**SUSQUEHANNA STEAM ELECTRIC STATION
REQUEST FOR ADDITIONAL INFORMATION (RAI) FOR THE
REVIEW OF THE SUSQUEHANNA STEAM ELECTRIC STATION
UNITS 1 AND 2, LICENSE RENEWAL APPLICATION (LRA)
SECTIONS 2.2, 2.3.3, 2.3.4
PLA-6276**

**Docket Nos. 50-387
and 50-388**

Enclosure: PPL Responses to Request for Additional Information (Sections 2.2, 2.3.3, 2.3.4)

LR-M-134-7

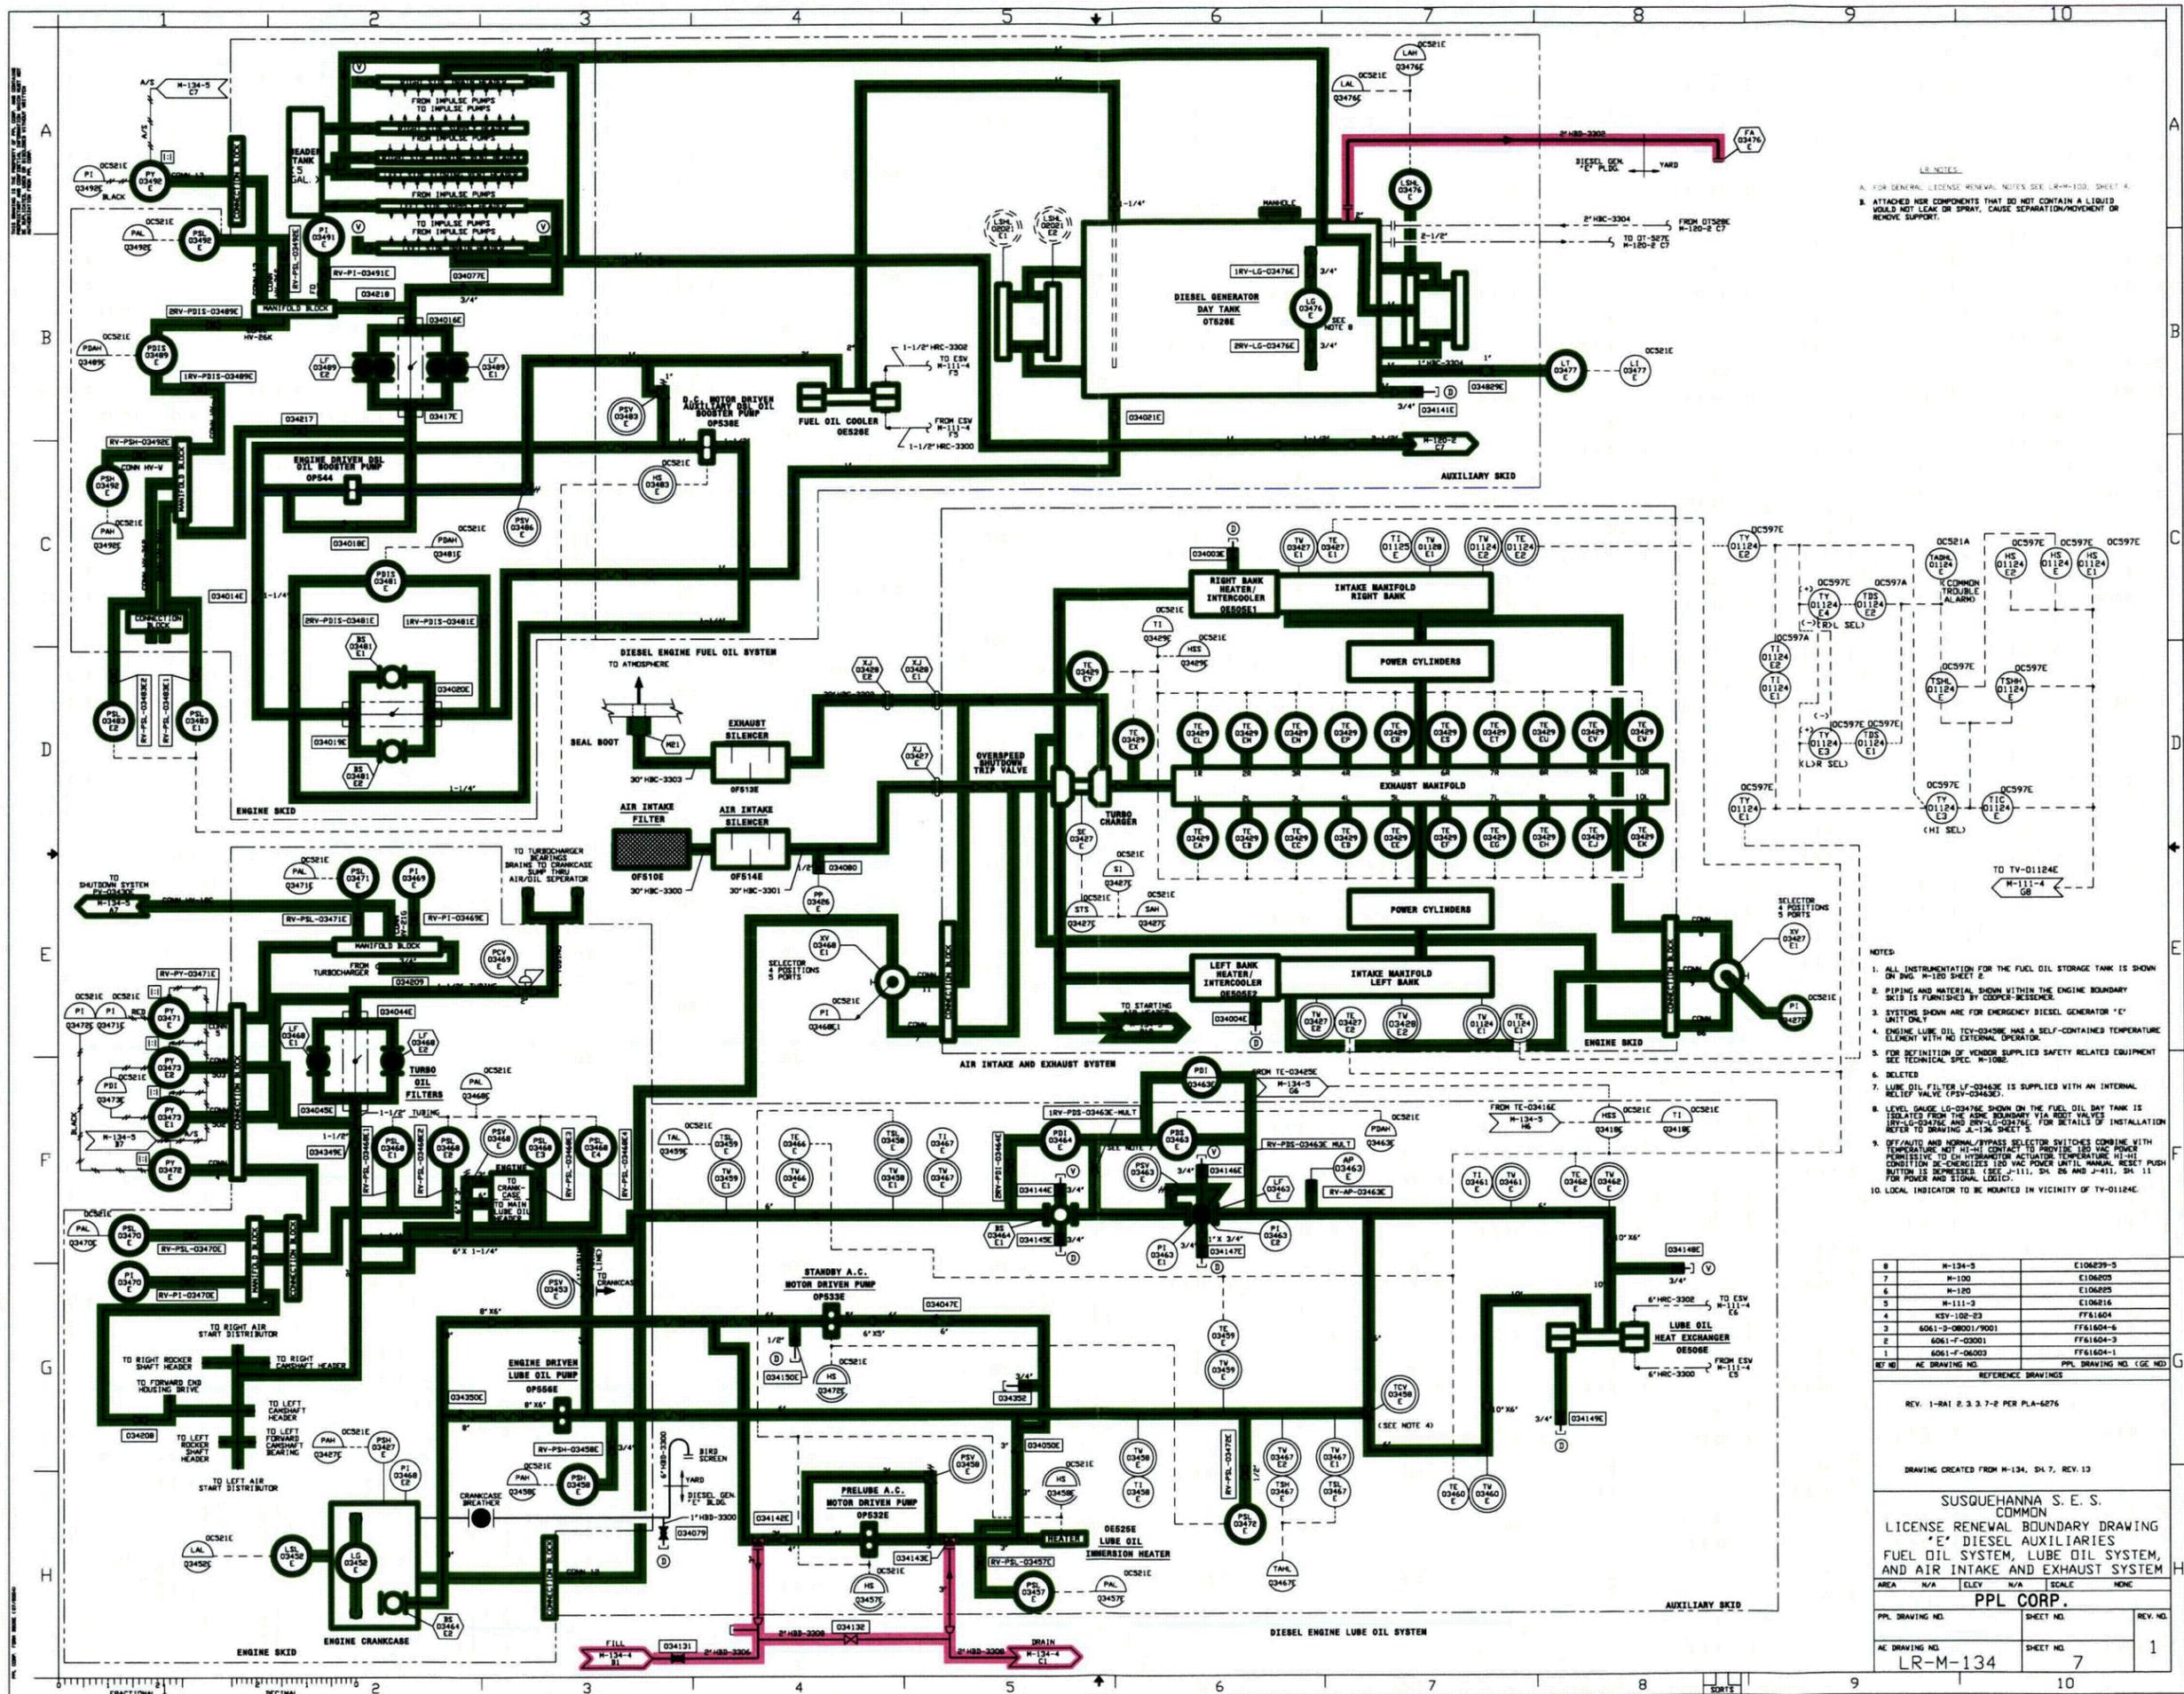
The diesel generator day tank flame arrestors shown on license renewal drawing LR-M-134-1, location F8, and drawing LR-M-134-7, location A8, are within the scope of license renewal, but are not included in LRA Table 2.3.3-7 for components subject to an AMR. The flame arrestor is typically included in the table because it is classified as a component subject to an AMR within the diesel fuel oil tanks. The flame arrestors are shown within the scope of license renewal for different reasons on the two drawings. Provide additional information explaining why the flame arrestors are shown within scope, but not included in Table 2.3.3-7, and why the flame arrestors are shown within scope for different reasons.

License renewal drawing LR-M-134-7, location A6, indicates that there is a manhole cover on top of the diesel generator day tank E and that it is within the scope of license renewal. Provide additional information explaining why the manhole cover is not listed in LRA Table 2.3.3-7 for components subject to an AMR.

The vent lines for the E diesel day tank on drawing LR-M-134-7 are nonsafety-related but are seismically qualified. This is supported by the HBD line designation which indicates that the piping is classified as ANSI B31.1.0. FSAR Table 3.2-1 supports the determination that the day tank vent lines are not safety-related. Per FSAR Section 9.5.4.3, the diesel generator fuel oil system is Seismic Category I. Therefore, the vent lines are within the scope of license renewal and are highlighted in pink (magenta) per LR-M-100-4 Note A2 up to the point where they exit the diesel generator building as they have the potential for spatial interaction with safety-related components. The boundary is extended through the end of the vent piping for the day tank, including the flame arrestor.

The manhole and cover depicted on license renewal drawing LR-M-134-7 is within the scope of license renewal. The manhole and cover are considered to be an integral part of the tank component. Therefore, the “Tanks (0T527A-E, 0T528A-E)” entry in Table 2.3.3-7 includes the associated manholes and covers. The manhole and cover perform the same pressure boundary function as the tank.

LR-M-141-1

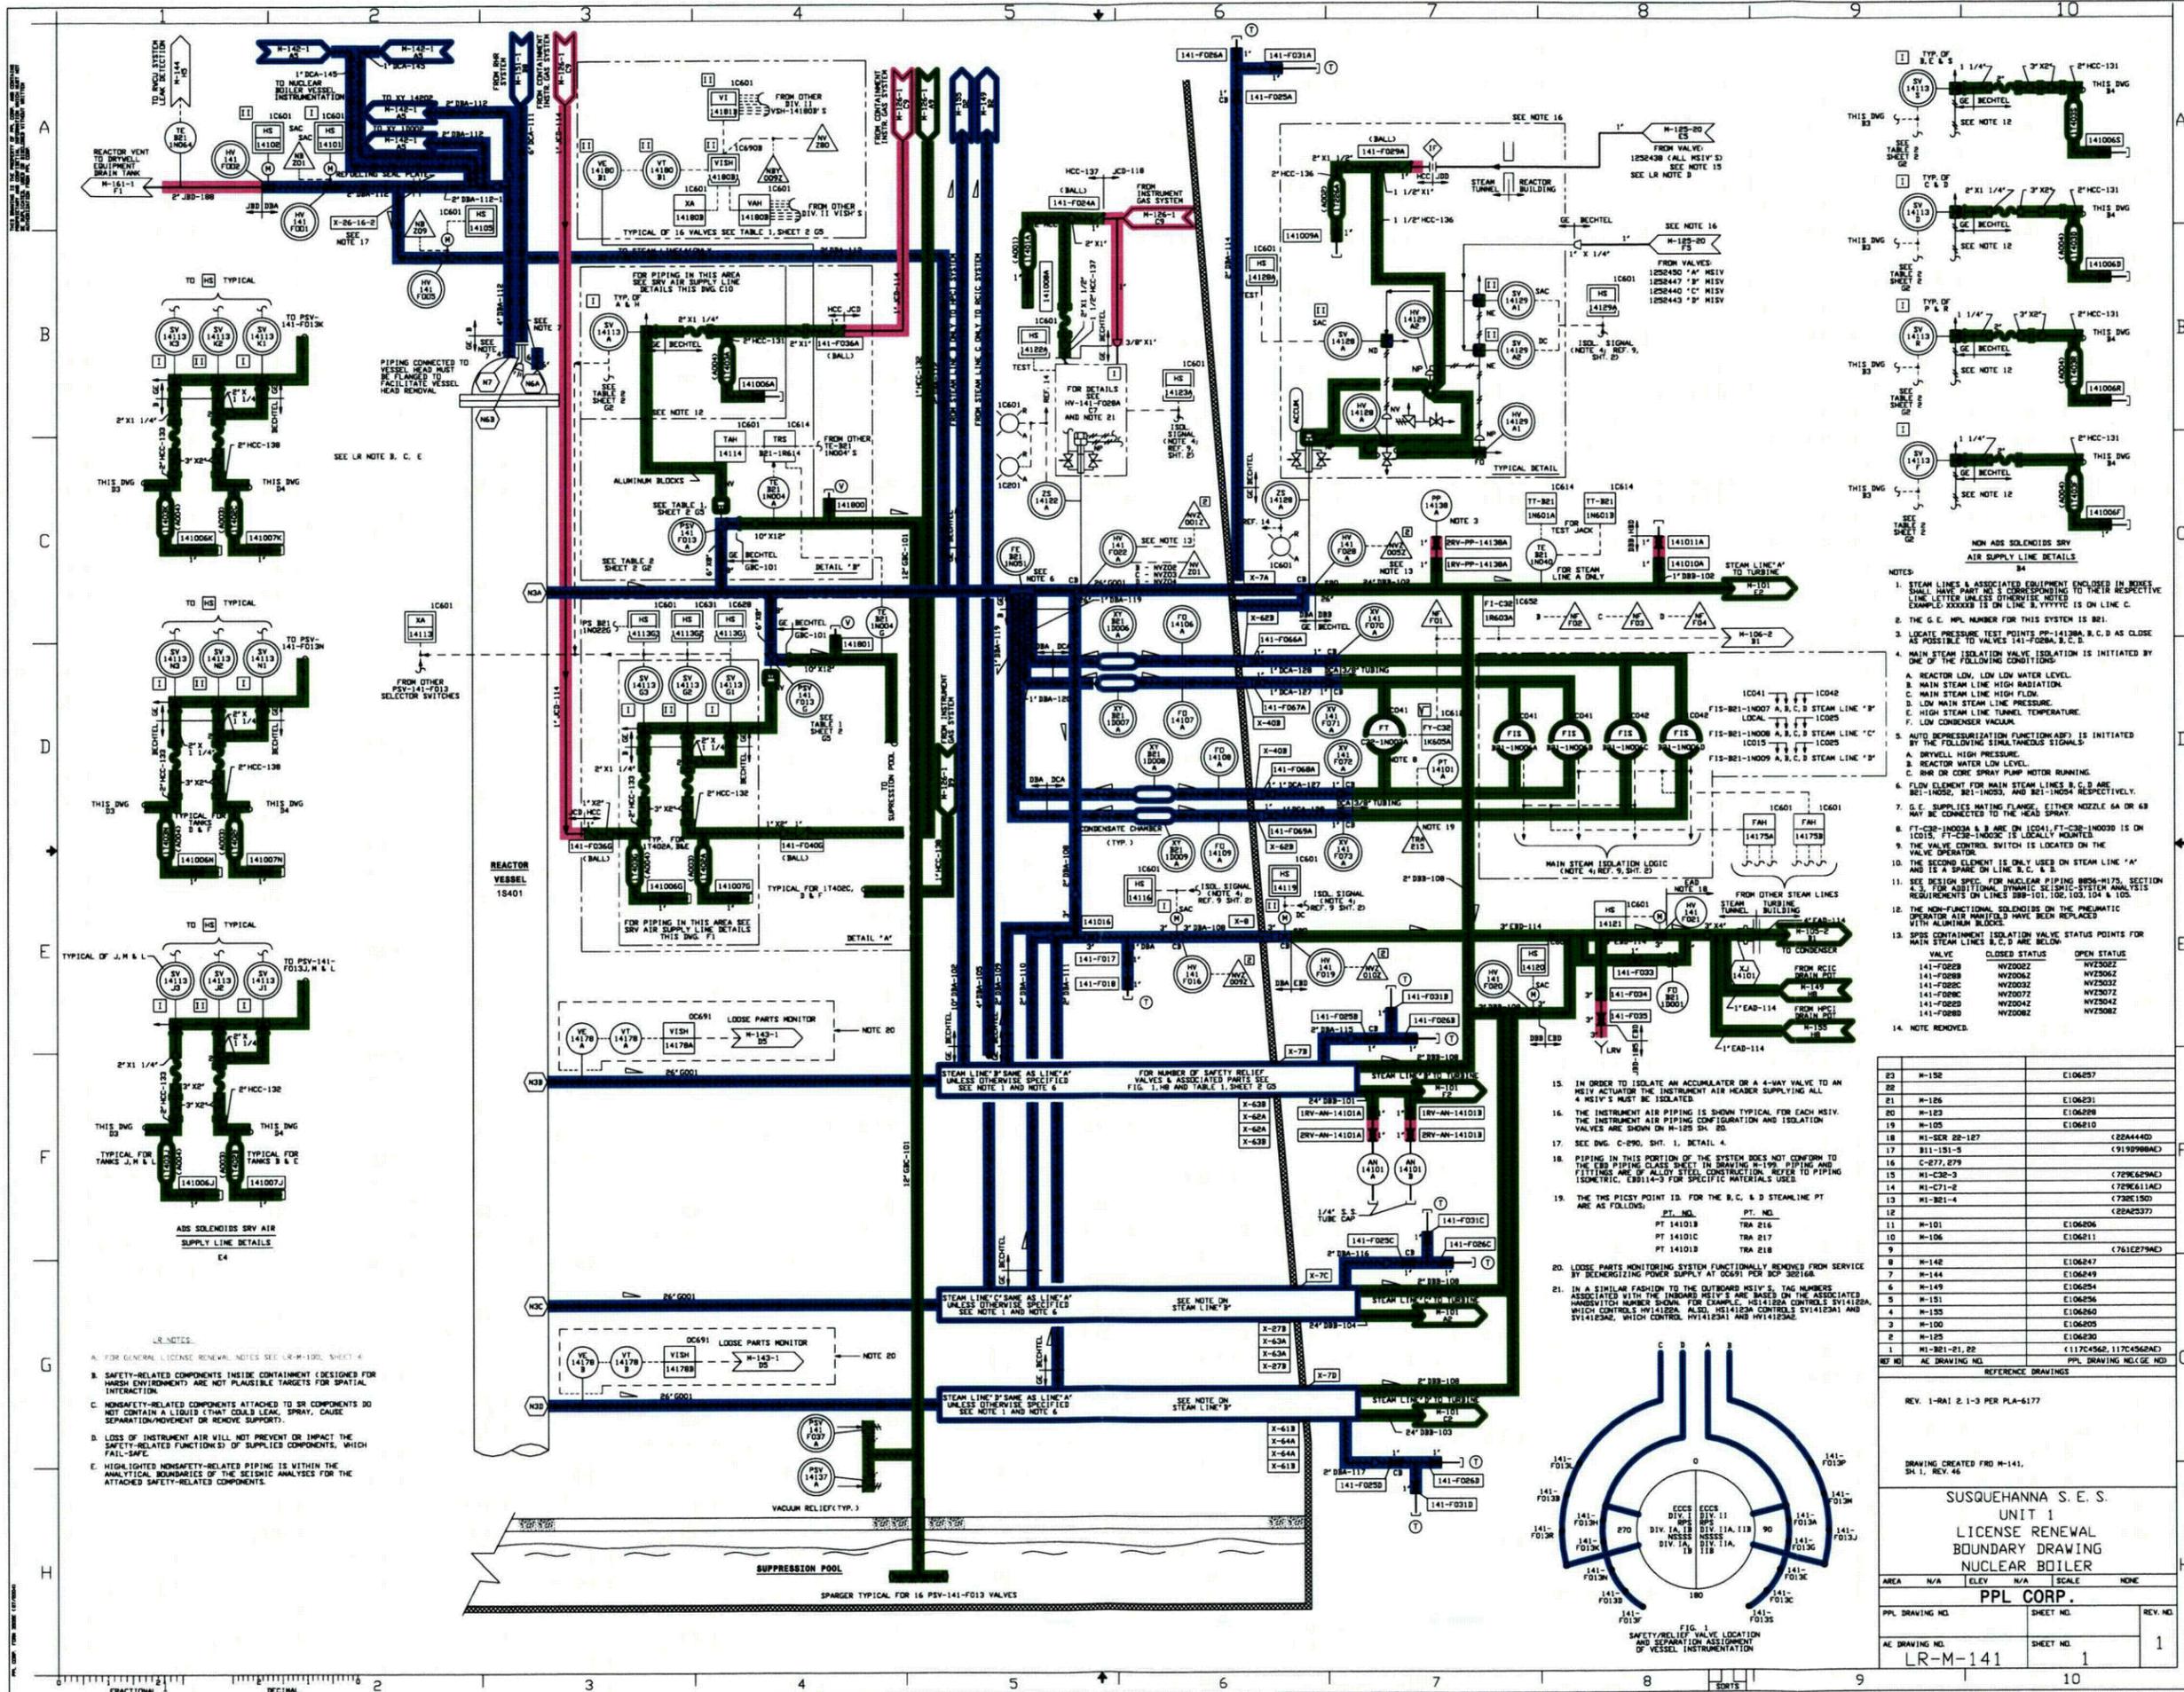
License renewal drawings LR-M-141-1, and LR-M-2141-1, locations A-7, upstream of 141F029A and 241-F029A show sections of ASME Section III Class 3 pipe as within scope of license renewal for 10 CFR 54.4(a)(2) (nonsafety-related spatial effects) as described in Note A2 on Sheet 4 of license renewal drawing LR-M-100. Since, ASME Class 3 components are safety-related (Regulatory Guide 1.26 Quality Group C), provide additional information explaining why these sections of pipe are not within scope for 10 CFR 54.4(a)(1).

License renewal drawings LR-M-141-1 and LR-M-2141-1, location A-7, shows the non-safety related (line class JDD) ANSI B31.1 piping connected to safety related (line class HCC) ASME Section III Class 3 piping not within the scope of license renewal. LRA Section 2.1.1.2.2, "Spatial Failures of Nonsafety-Related SSCs," page 2.1-8 states in part: "With respect to nonsafety-related piping that is directly connected to safety-related piping, the seismic Category I design requirements are extended to the first seismic restraint beyond the defined boundaries." Provide the location of the license renewal boundary (seismic restraint) for the nonsafety-related piping connected to the safety-related piping.
